Planning stage structural report

150 Day Street

Prepared for UOL / 20th March 2025

Issue: Revision 2

INTERNAL FOUNDATION STRENGTHENING STRATEGY

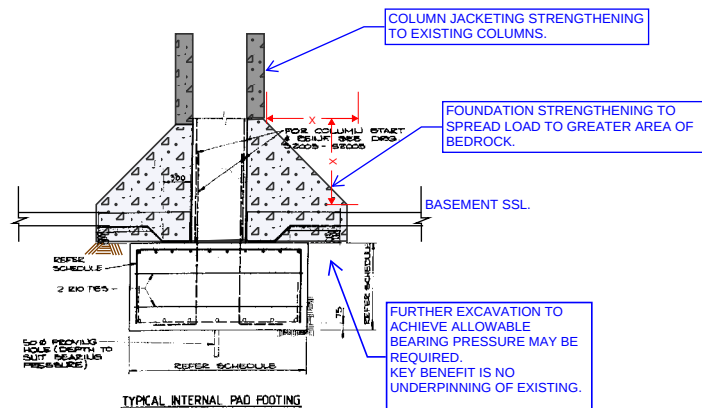
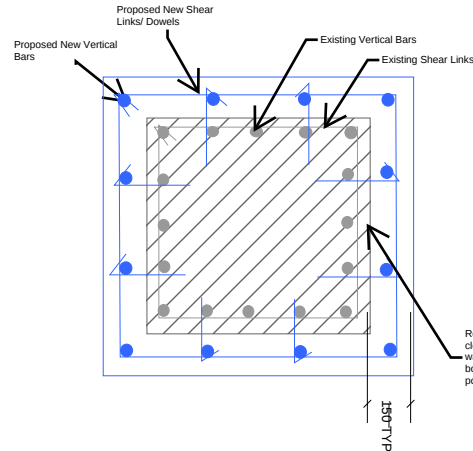
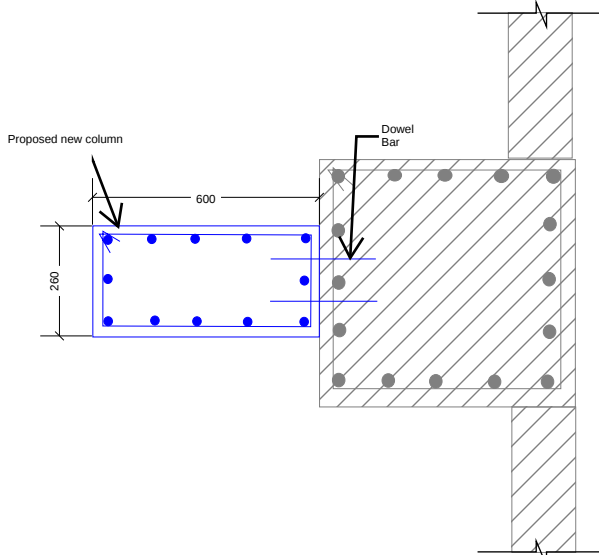
APPROXIMATE LOCATION OF GEOTECHNICAL
FAULT ZONE THROUGH SITE, WITH LOWER
ALLOWABLE BEARING CAPACITY

APPROXIMATE LOCATION OF CROSS
CITY TUNNEL.
DEPTH AND LOCATION TO BE
CONFIRMED, ALLOW FOR
CONSULTATION WITH STAKEHOLDERS
TO DISCUSS IMPLICATIONS OF
ADDITIONAL STOREYS ON FOUNDATION
FORCES.

ALLOW FOR EXCAVATION AND NEW FOOTING AT EACH LOCATION SHOWN DOTTED.
AT THESE LOCATIONS, EXISTING FOOTING WILL LIKELY REQUIRE EXTENSION TO
PROVIDE BASE TO STRENGTHENED PERIMETER COLUMN.

FOOTING TO BE ENTIRELY BELOW EXISTING BASEMENT SSL TO NOT INTERRUPT
EXISTING PLENUM AND DRAINAGE.
SEE COLUMN STRENGTHENING DETAILS IN THIS REVIEW SET FOR MORE
INFORMATION.
INTENTION AT THESE AREAS IS THAT BACK-PROPPING, JACKING AND
UNDERPINNING BE MINIMISED AND ELIMINATED IF POSSIBLE.

EXISTING LIFT CORE TO BE STRENGTHENED
BY WRAPPING WITH 350 THICK CONCRETE.
FOOTING STRENGTHENING VIA
UNDERPINNING SHOULD BE ALLOWED FOR AT
EXISTING LIFT LOCATION.

ALLOW FOR INTERNAL RETURN COLUMN ON INSIDE FACE. NEW LOADS FROM
ADDITIONAL STOREYS TO LOAD DIRECTLY INTO THESE EXTENSIONS.
PLAN GEOMETRY OF STRENGTHENED SECTION MAY BE MODIFIED, AT TYPICAL
HOTEL FLOOR INTENTION IS FOR COLUMN TO FIT WITHIN HOTEL WALL.

DRAWING TITLE
BASEMENT 01 PLAN

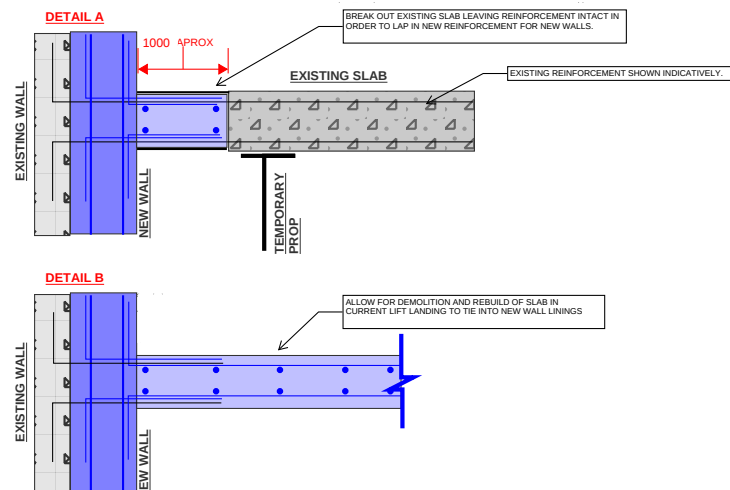
APPROXIMATE LOCATION OF SYDNEY WATER SEWER PIPE (300DIA VITRIFIED CLAY) AS IDENTIFIED IN DIAL BEFORE YOU DIG PLAN.

SEE TTW PLANNING STAGE REPORT FOR COMMENTARY ON IMPLICATIONS AND POTENTIAL REQUIREMENTS FOR A SYDNEY WATER SPECIAL ENGINEERING ASSESSMENT OF THIS ASSET.

1 L01 PLAN
RS_020 1:200

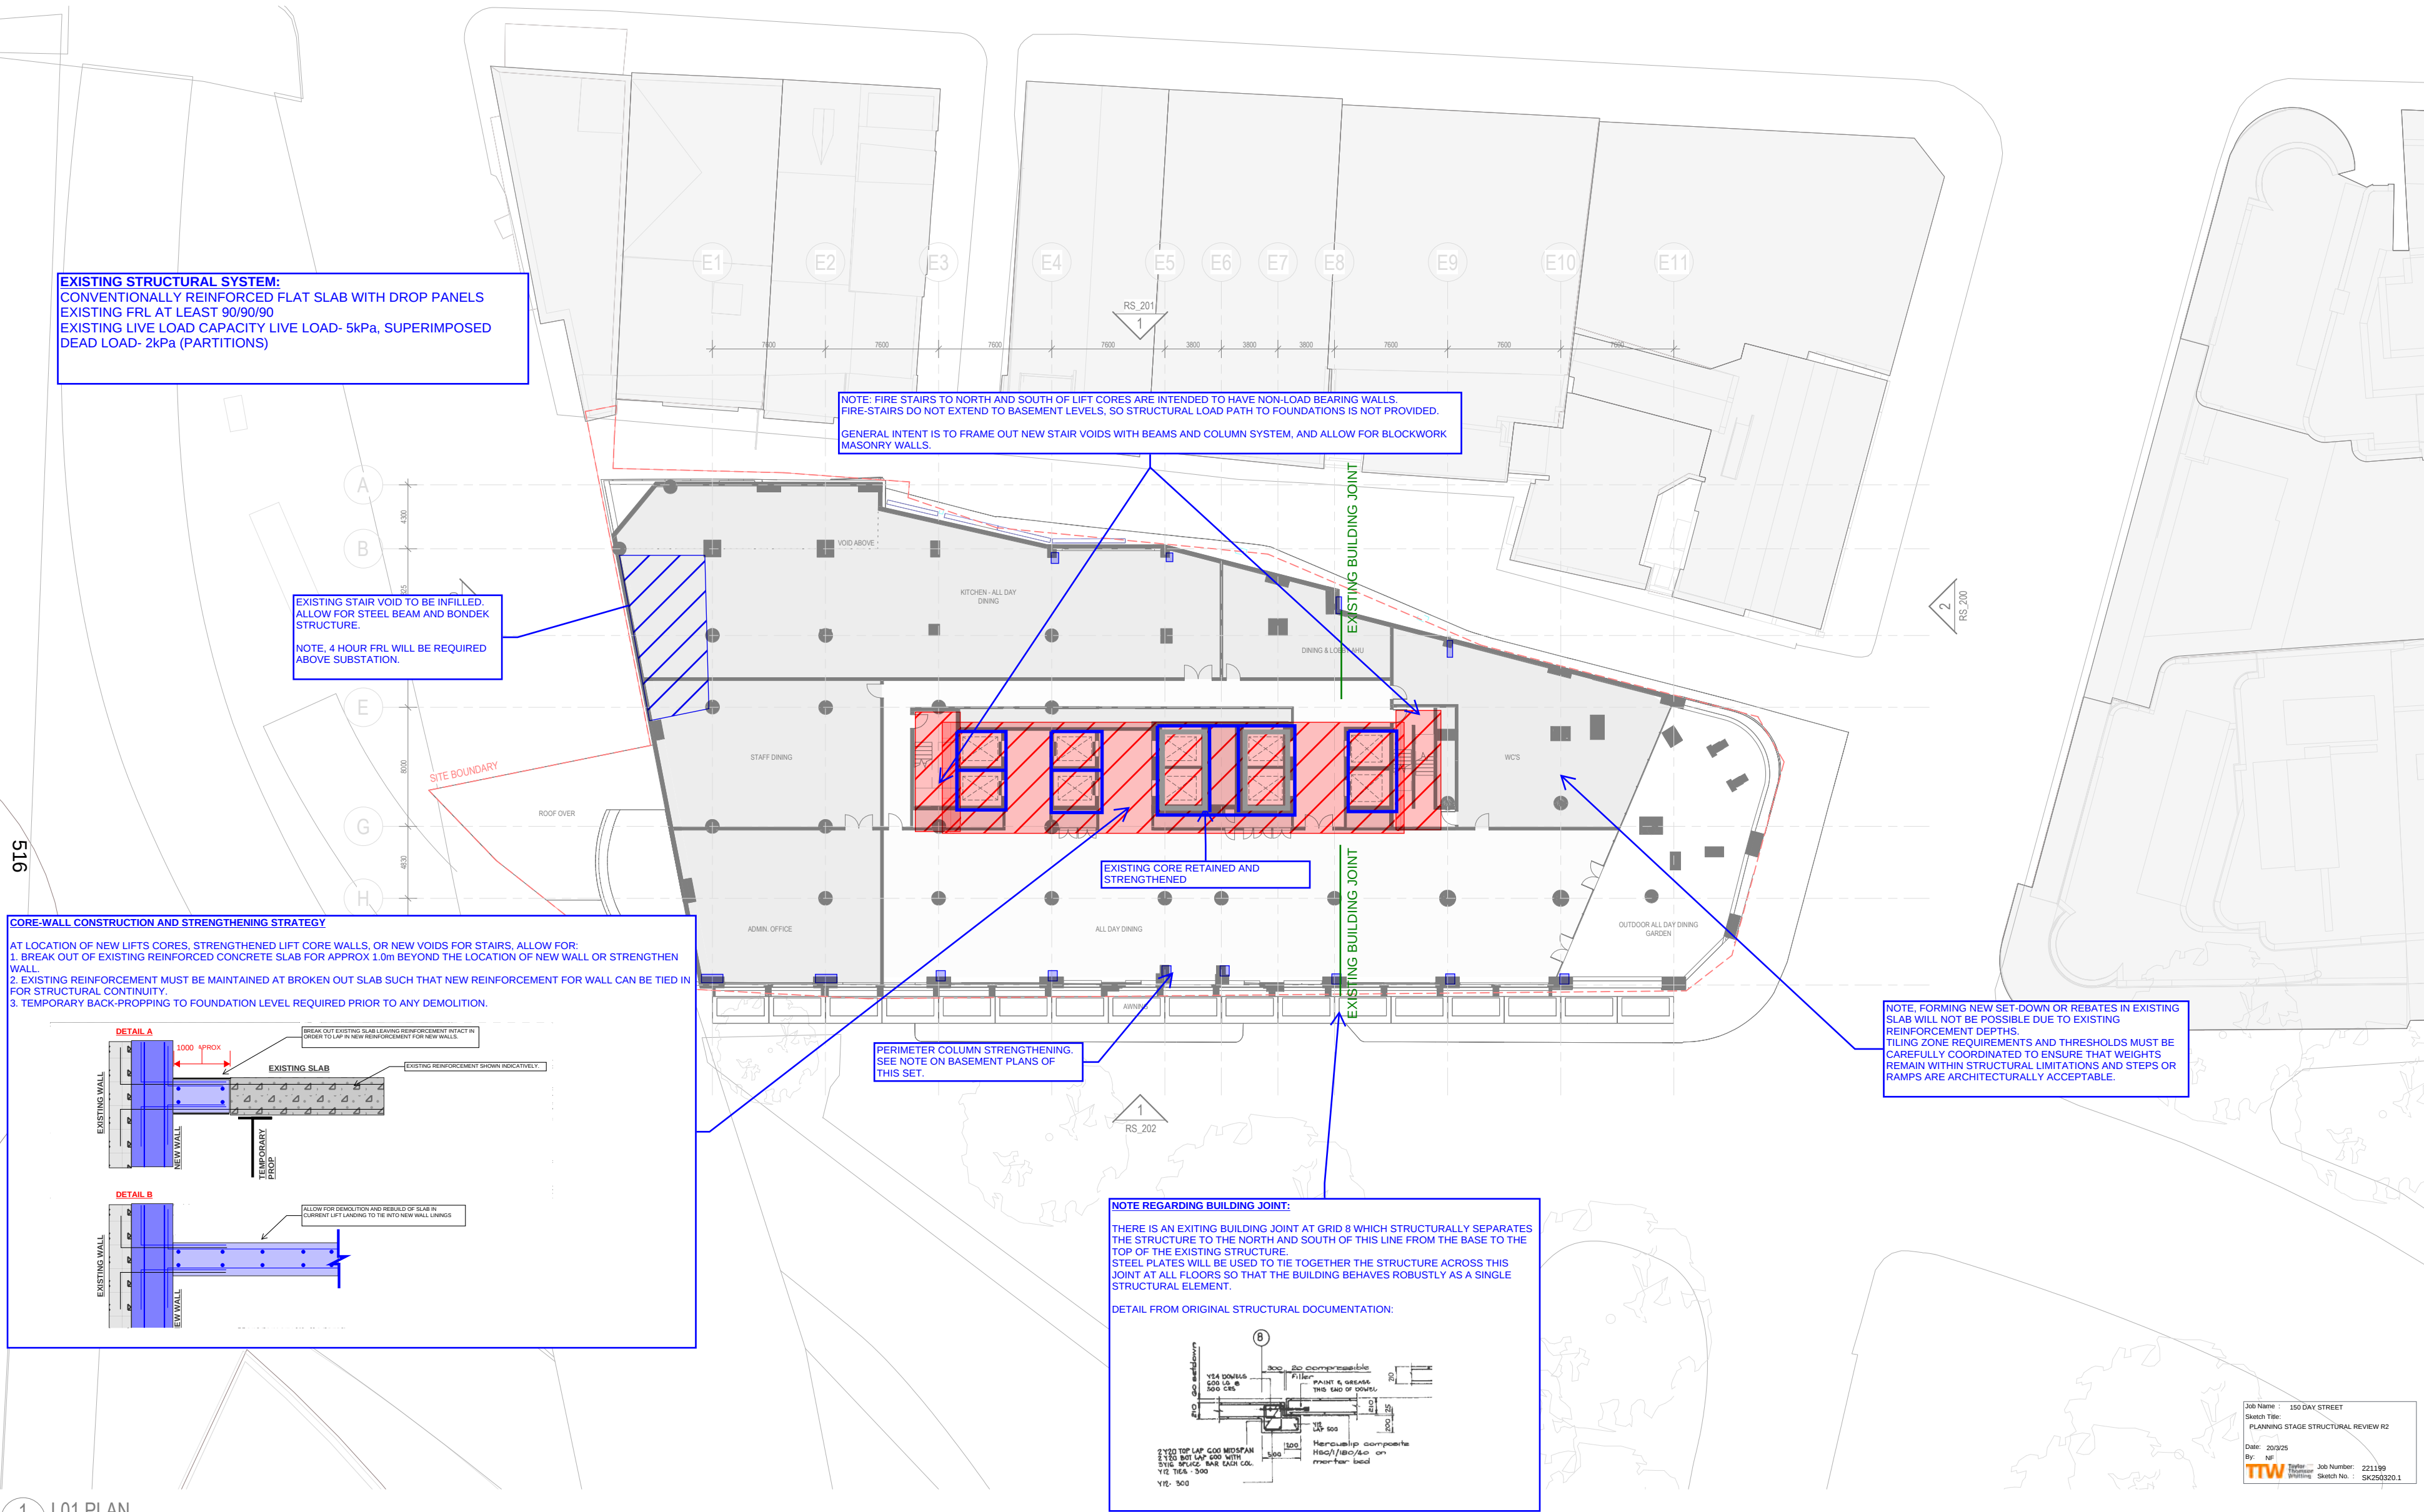
ALLOW FOR EXCAVATION AND NEW FOOTING AT EACH LOCATION SHOWN DOTTED. AT THESE LOCATIONS, EXISTING FOOTING WILL LIKELY REQUIRE EXTENSION TO PROVIDE BASE TO STRENGTHENED PERIMETER COLUMN.

SEE GENERAL STRATEGY FOR
PERIMETER COLUMN STRENGTHENING
NOTED ON B2 PLAN.

SOUTHERN PORTION OF EXISTING B1
STRUCTURE BEARS DIRECTLY ON GROUND.

1 L02 PLAN
RS_020 1:200

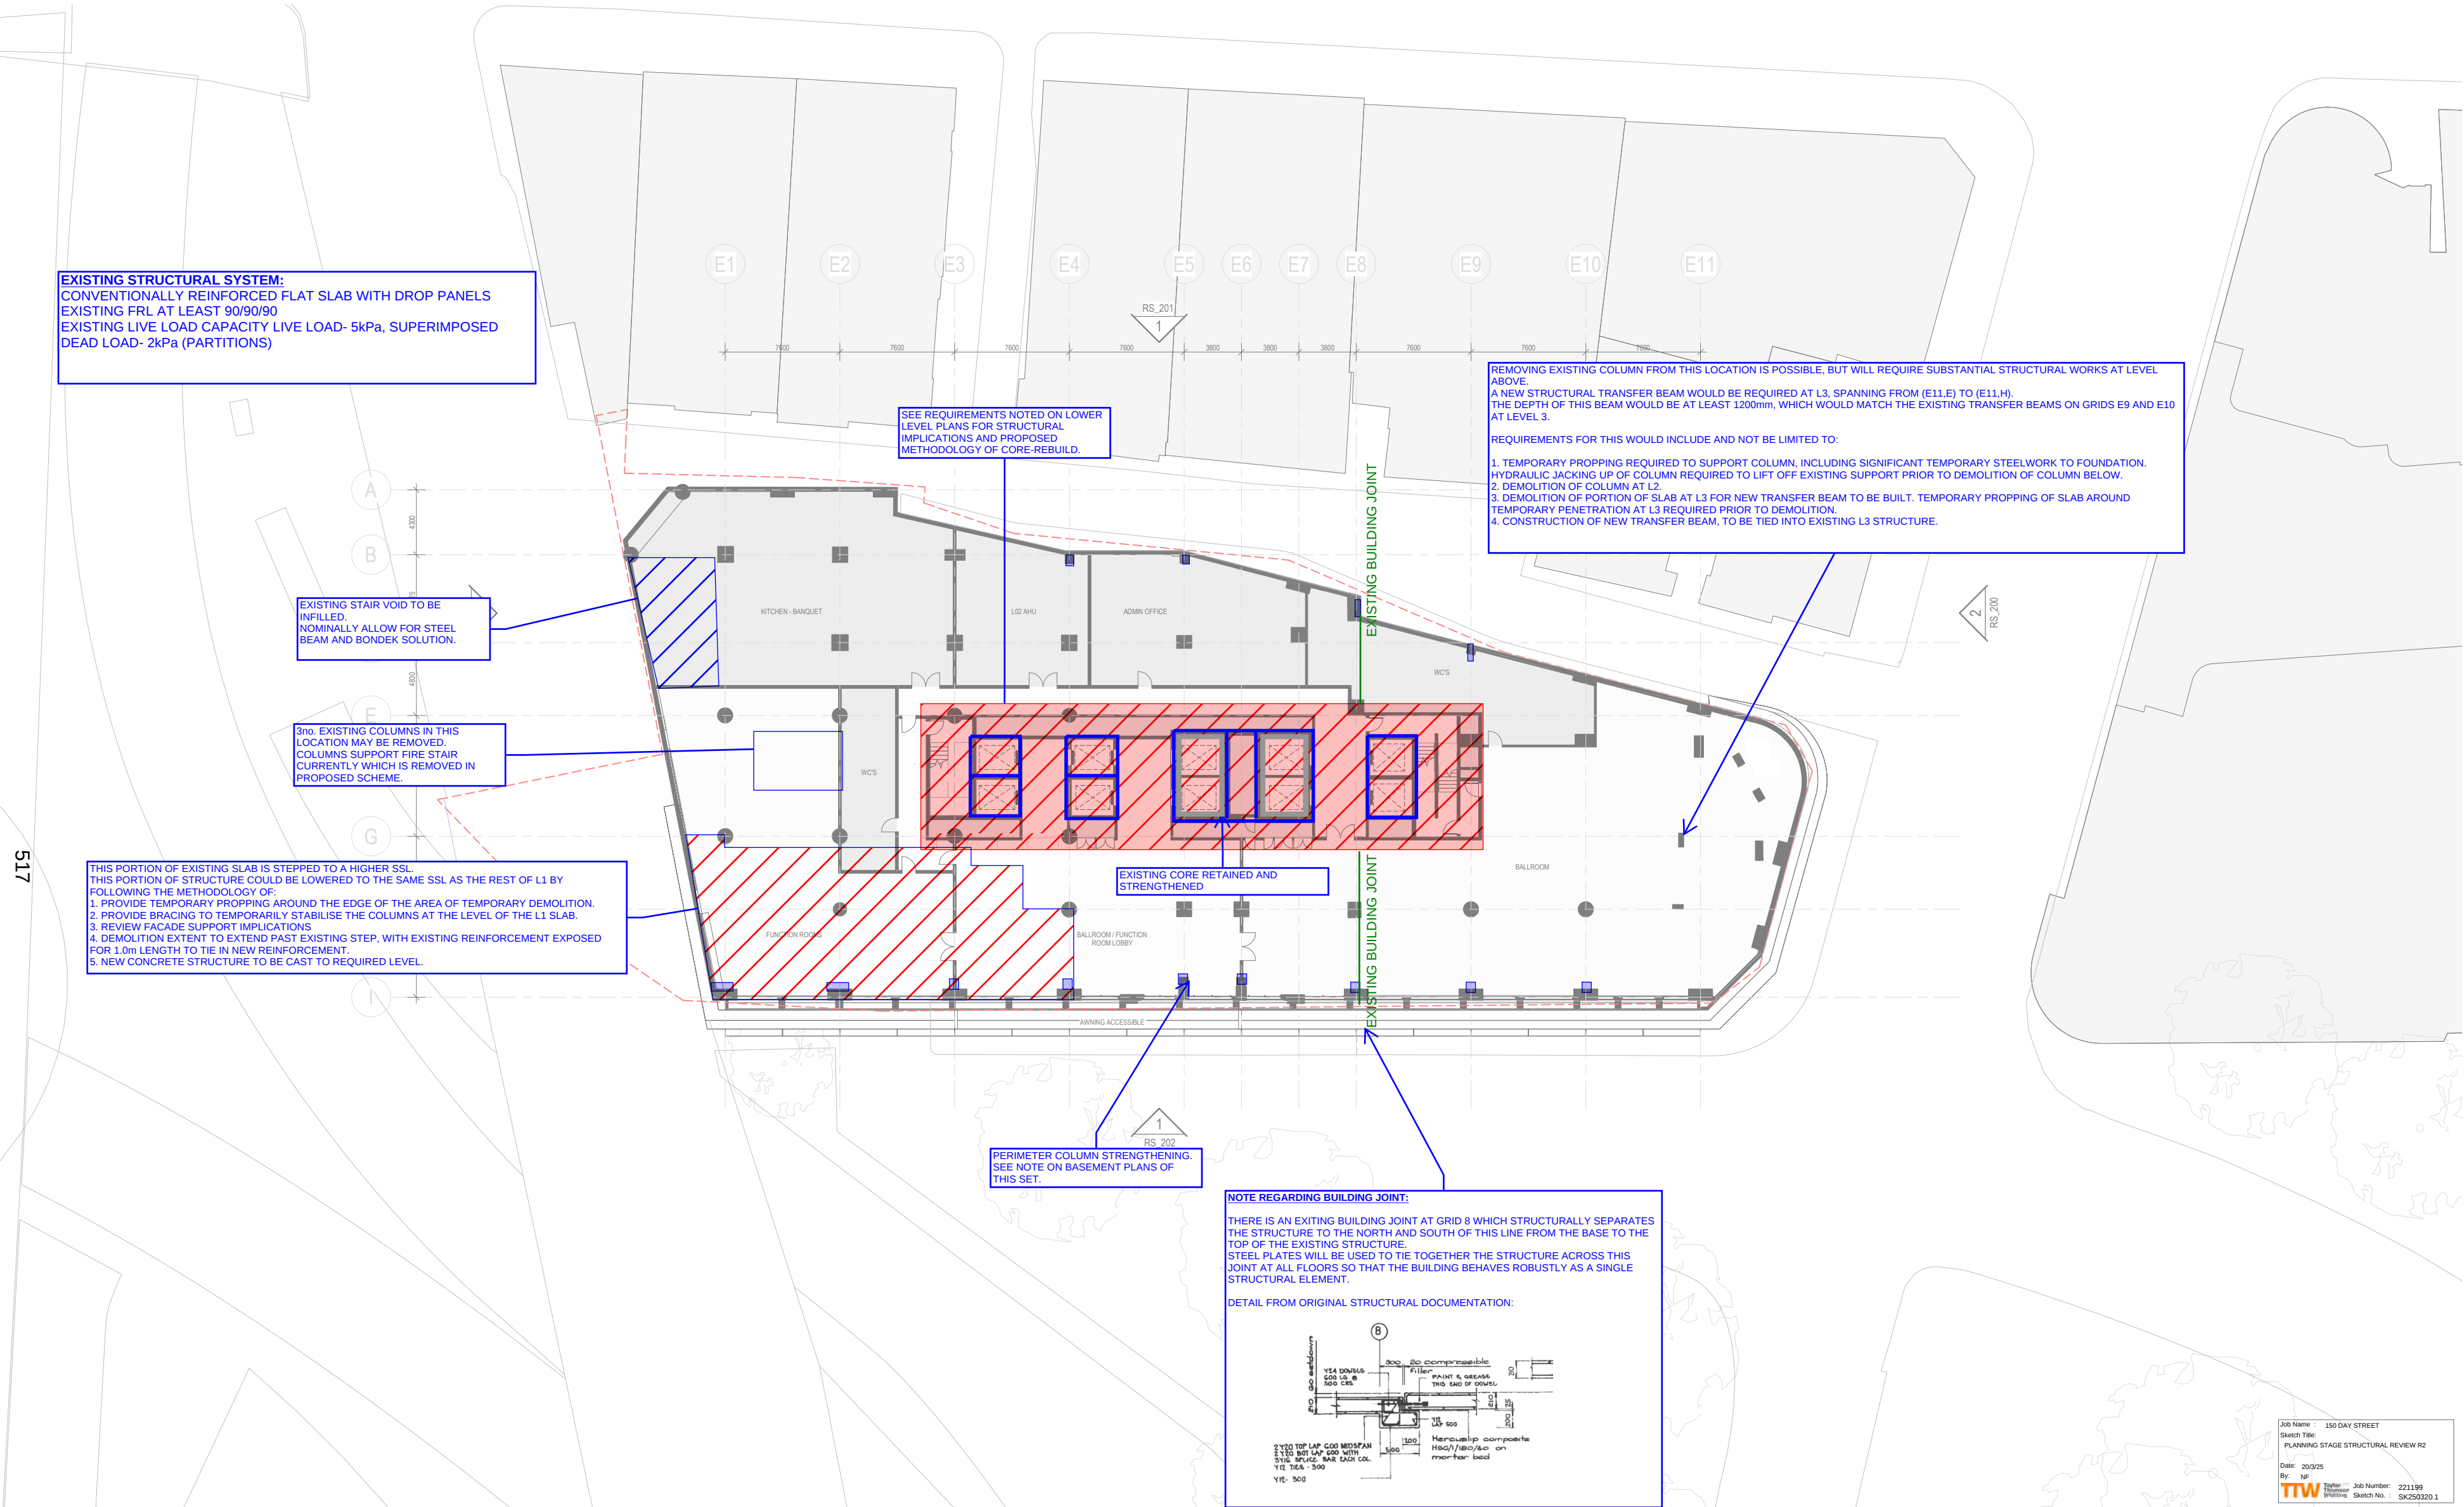
SEE REQUIREMENTS NOTED ON LOWER LEVEL PLANS
FOR STRUCTURAL IMPLICATIONS AND PROPOSED
METHODOLOGY OF CORE-REBUILD.

EXISTING FIRE STAIR AND ATRIUM VOID IN
FILLED WITH STRUCTURAL STEEL BEAMS AND
BONDEK IN ARRANGEMENT SHOWN.

GENERAL SOLUTION TO INFILL EXISTING
STAIR VOIDS WITH BONDEK AND
STRUCTURAL STEEL FRAMING.

SEE NOTE ON LEVEL 2 PLAN REGARDING
WHAT WOULD BE REQUIRED IN TERMS
OF BUILDING A NEW TRANSFER BEAM
TO REMOVE COLUMN AT L2.

PERIMETER COLUMN STRENGTHENING
GENERAL INTENT OF WORKS AS PER NOTES ON B2 SHEET OF THIS SET.

THERE IS AN EXITING BUILDING JOINT AT GRID 8 WHICH STRUCTURALLY SEPARATES
THE STRUCTURE TO THE NORTH AND SOUTH OF THIS LINE FROM THE BASE TO THE
TOP OF THE EXISTING STRUCTURE.
STEEL PLATES WILL BE USED TO TIE TOGETHER THE STRUCTURE ACROSS THIS
JOINT AT ALL FLOORS SO THAT THE BUILDING BEHAVES ROBUSTLY AS A SINGLE
STRUCTURAL ELEMENT.

NOTE ON REQUIREMENTS FOR TRUNCATING EXISTING POST-TENSIONING.

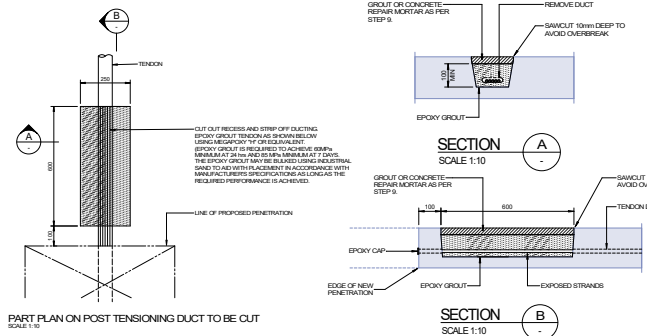
FOR NEW LIFT AND STAIR SOUTH OF GRID E8 IN PARTICULAR.

TRUNCATION OF EXISTING POST-TENSIONING WILL BE REQUIRED TO FORM NEW OPENING FOR LIFT AND STAIR VOID. DETAILED ANALYSIS REQUIRED AT NEXT DESIGN STAGE IN ORDER TO ASSESS ANY ADDITIONAL STRENGTHENING IN ADJACENT SLAB WHICH MAY BE REQUIRED TO FACILITATE THIS TRUNCATION.

3. For each tendon to be cut, carefully remove a 600 long by 250 wide strip of concrete from above and around the tendon 50mm from the penetration. DO NOT CUT ANY REINFORCEMENT. Strip off the slabs and clean out the existing grout.

7. Cut the slab into manageable chunks and remove them.
8. Remove the platform and props.
9. Fill top portion of strip with 21 sand cement grout or Rendicrete HF for internal applications and Rendicrete HB40 Plus for external applications or areas with no applied finishes. Fill in to be finished with surrounding concrete surface.

OPTION 1: OPTIMISED IRREGULAR TRUSS
TOTAL STEEL WEIGHT FOR COSTING, APPROXIMATELY 450kg/m

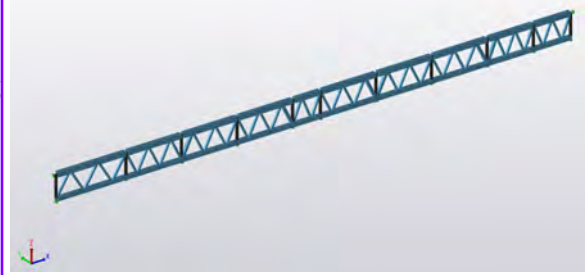
OPTION 2: NON-OPTIMISED REGULAR TRUSS
TOTAL STEEL WEIGHT FOR COSTING, APPROXIMATELY 1100kg/m
